Technical Bulletin 181

TCI Toolkit Upgrade Notice

Totalflow Technical Bulletin
Version 1.0 Revision AD (3/12/2010)

Example Collection and Retry Transactions:

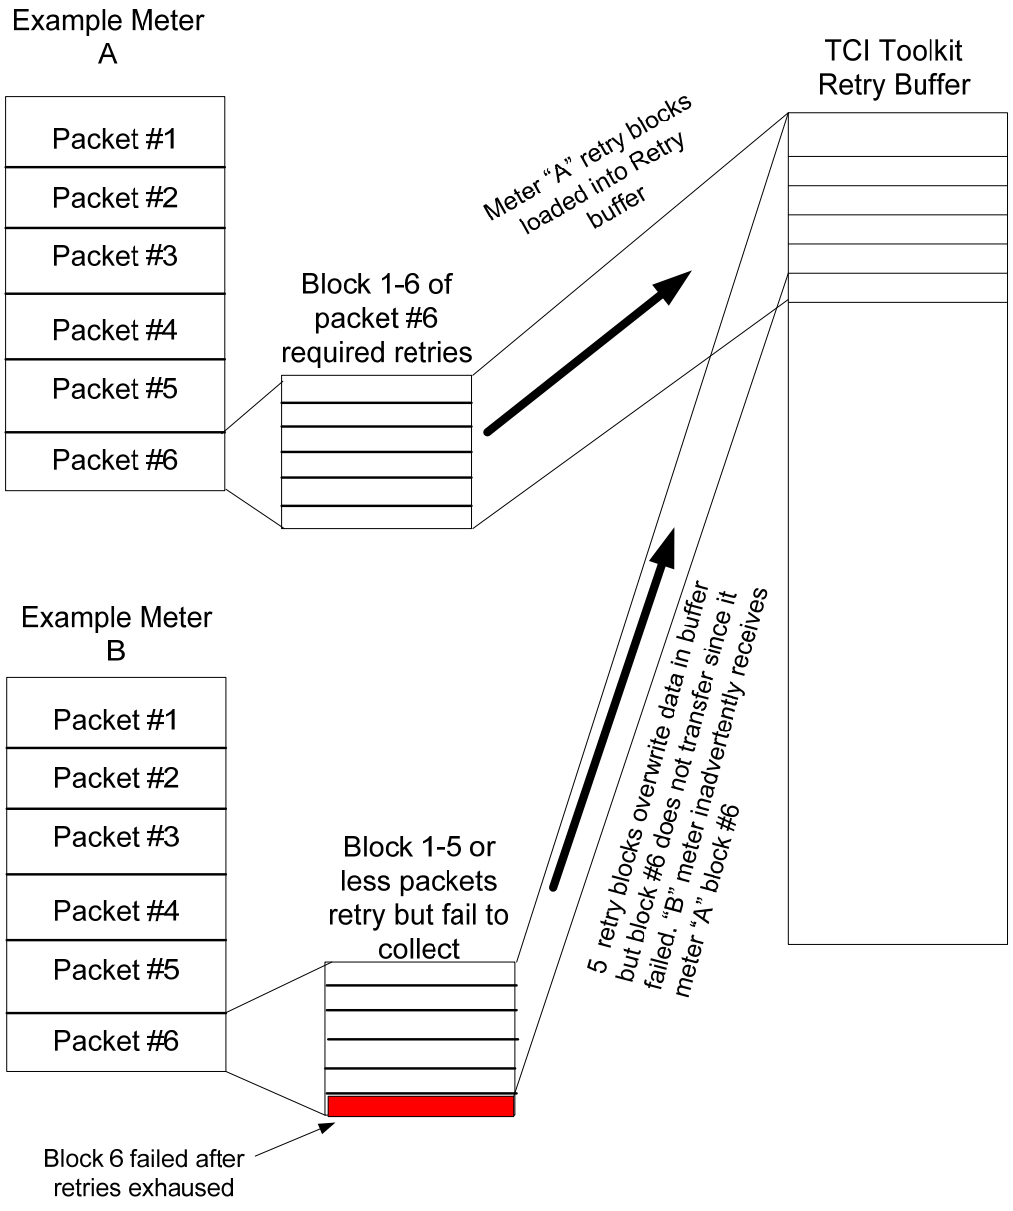
Meter "A" and "B" are in a scheduled historical collection list. In this example, 6 packets of data are successfully collected from meter "A" with at least two blocks having to be retried due to bad blocks. These re-transmitted blocks are stored in a temporary TCI retry buffer before stitched to the good blocks and transferred to database (see diagram below).

The number of re-transmitted blocks from meter "B" must be at least one fewer than the number re-transmitted from meter "A" to cause this overwrite condition.

In this example, 6 packets of data are collected from meter "B" with an error on packet #6. Successful retry packets 1-5 are moved to the buffer and the TCI toolkit accepts block #6 from meter "A" as valid since it passes the CRC data integrity test. This incorrect handling of data is due to the fact that the TCI retry buffer was not initialized and zeroed between meter collections.

It is recommended that all third party SCADA packages using Totalflow's TCI toolkit upgrade to version 2.2.5.6 (part# 2100838-015) or later. Any version prior to this release (2.2.5.5 or earlier) will have the issue described above. Contact your ABB sales representative or our technical service department (800-442-3097 option #2) for this important upgrade.
